From: Allison, Rick
Sent: Monday, December 19, 2011 8:51 AM
To: 'KMiller@nobleenergyinc.com'
Cc: JKajiwara@nobleenergyinc.com
Subject: RE: Grigsby AC19-62HN Form 2A 400215367 - Noble Energy, Inc.

I am reviewing the Form 2A location assessment for the Grigsby AC19-62HN well location in the NENE Sec30 T7N R63W, Weld County and have the following comments:

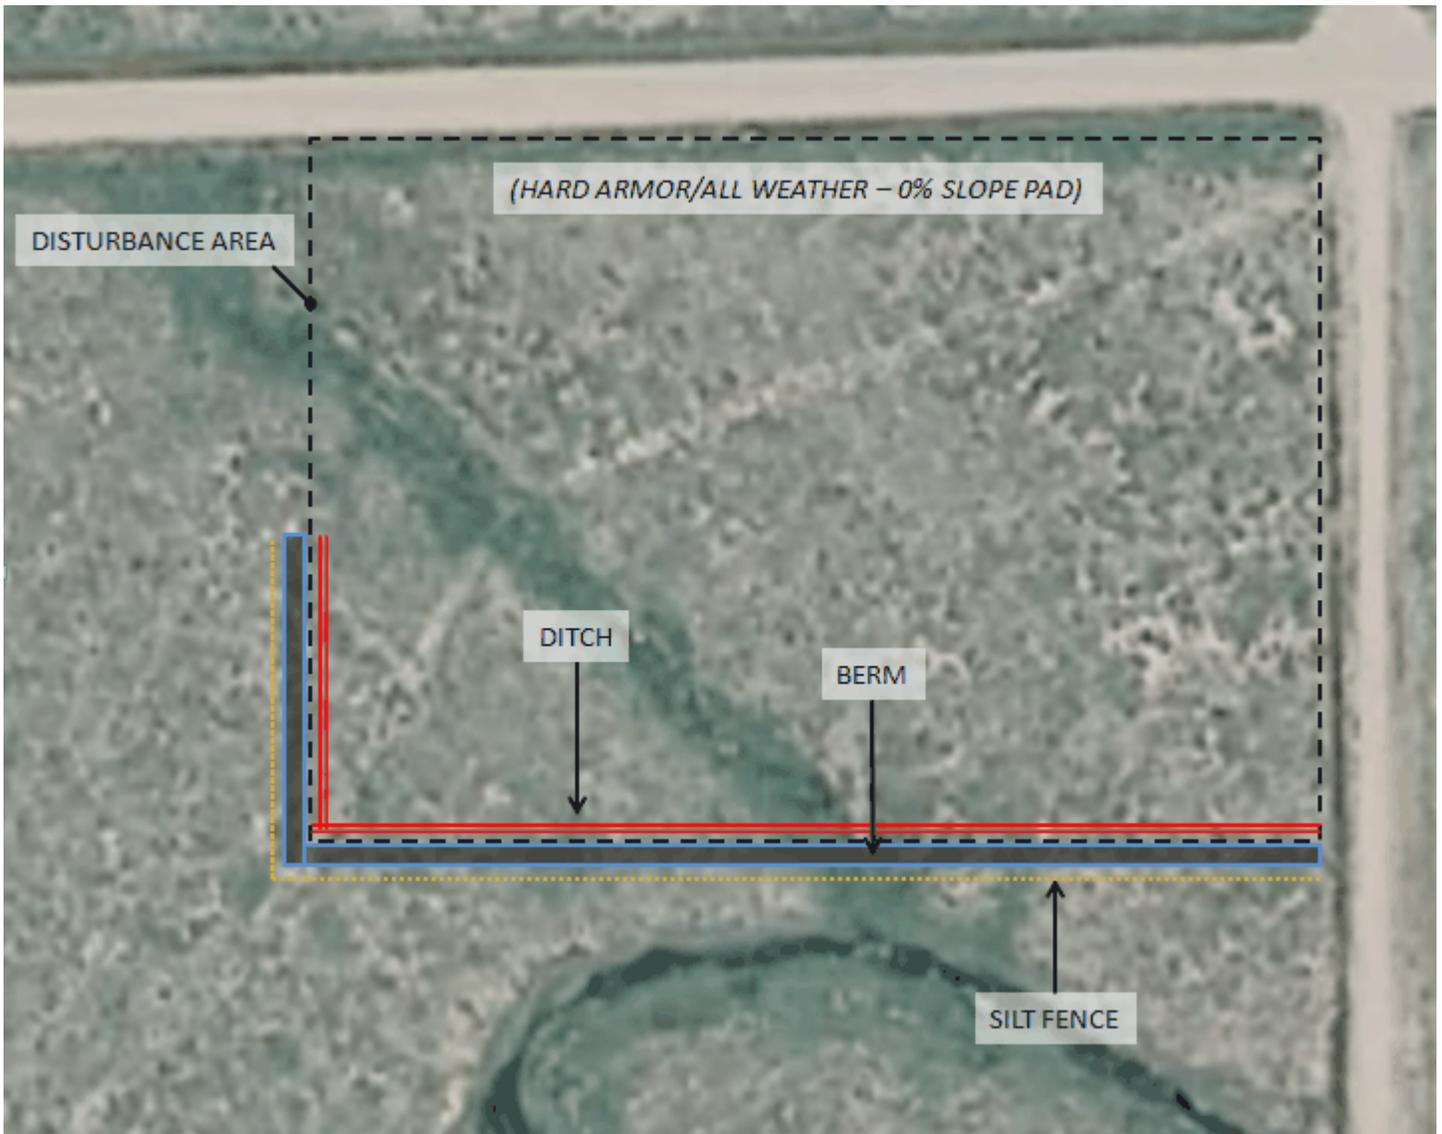
1. Construct a hard armor/all weather pad as close to zero percent as possible. (Restricting fluids from to flow in any direction)
2. Construct a ditch and berm along half of the west, and all of the south sides of the pad disturbance area. (The ditch is intended to collect and contain any possible fluids. Berm is created just beyond ditch to keep any fluids within the ditch from spill over)
3. Place silt fencing just beyond the ditch & berm. (The silt fence's purpose is to act as a filter for any fluids that may run

over the said ditch & berm, containing sediments within the fluids from impacting stream. The fencing will also be a visible boundary for workers to respect the wetlands area around the stream. Fluid overflow from the ditch & berm is highly unlikely but will be put in place to serve as the final line of defense.)

- You will find below that I have put together an aerial correctly depicting our plans of operations. With these protective measures put in place we should meet 4 BMP's (Best Management Practice), and succeed in preventing any possible fluids from reaching the stream to the south of our pad. I hope that this may help with any concerns or questions regarding our operations.

I have a question regarding the silt fence. Silt fence is designed to allow water (fluids) to pass through, trapping the silt. Therefore, it would not be effective in containing a release of fluids on the location. However, the berm appears to be a reasonable measure for containing a release of fluids during drilling and completion. The silt fence could be useful to make people on location aware of the location boundary, thereby helping protect the berm from being unintentionally breached or compromised.

Is the silt fence really intended to hold fluids or will it be installed for some other purpose? Please explain how it can contain fluids if that is the case.

1. Construct a hard armor/all weather pad as close to zero percent as possible.
2. Construct a ditch and berm along half of the west, and all of the south sides of the pad disturbance area.
3. Place silt fencing just beyond the ditch & berm.
4. Production facilities will be placed in the northeast corner of the location.”

Please note that silt fence will not contain spilled fluids. However, the ditch and berm appear to be reasonable measures to protect the stream channel. The silt fence can be effective as a sediment catch and to define the disturbance boundary.
